GOVERNMENT OF THE DISTRICT OF COLUMBIA
DEPARTMENT OF TRANSPORTATION

MEMORANDUM

SUBJECT: ZC Case No. 11-03C – The Wharf Parcel 1: Market Square and Market Shed, 1000 Maine Avenue SW

Figure 1. Site Plan (Source: Applicant)

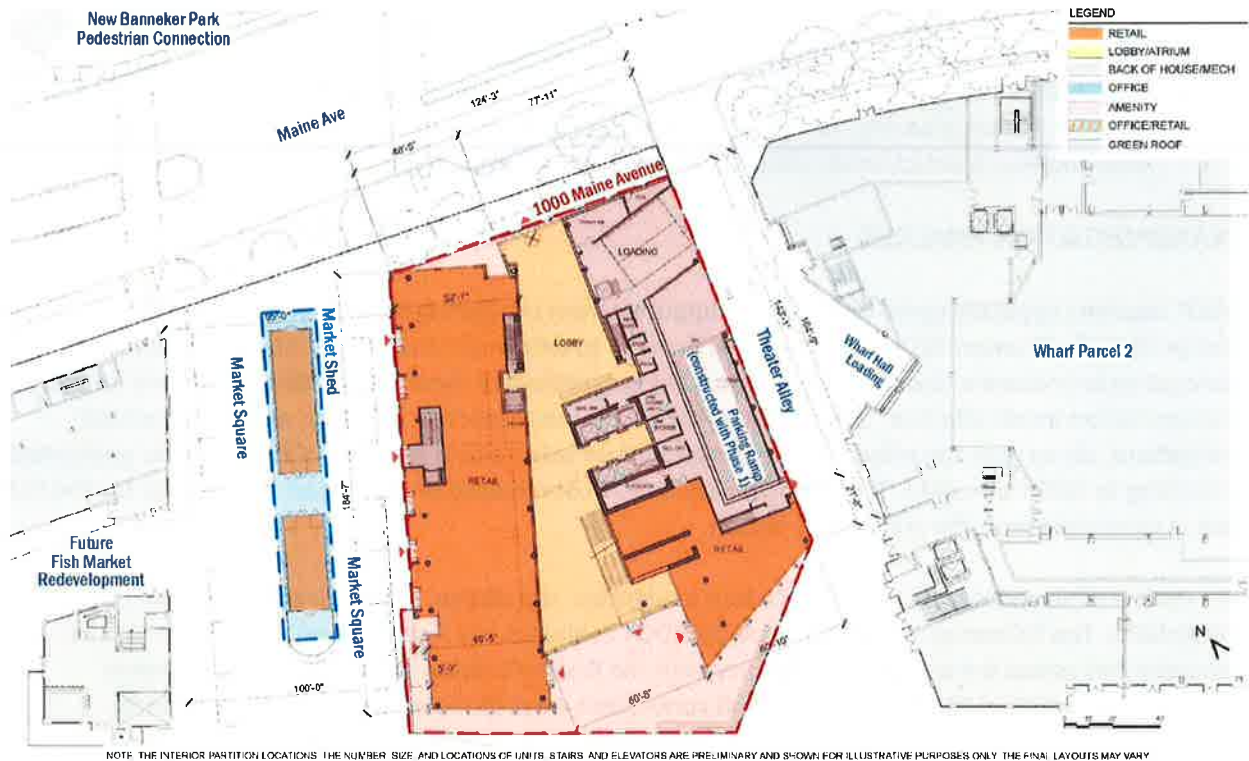
This Site is located along Maine Avenue SW near the location of the historic Fish Market, and at the northwest end of the overall Wharf development. The proposed Site plan is shown in *Figure 1*. Loading vehicles access the Site from the north at an alley off Maine Avenue. Personal vehicles access the Site via the same alley, which leads to an underground parking garage with 78 dedicated vehicular parking spaces for the building (and an overall count of 1,495 parking spaces serving the entire Phase I). An additional driveway provides access around the Market Shed and to the historic Fish Market, and as well to 11 surface parking spaces. The proposed vehicle site access is consistent with DDOT's approach to site access.

Pedestrian access points are found surrounding the main Parcel 1 building, mainly along Market Square. Bicyclists can access via the parking entrance, or park at a rack near the building.
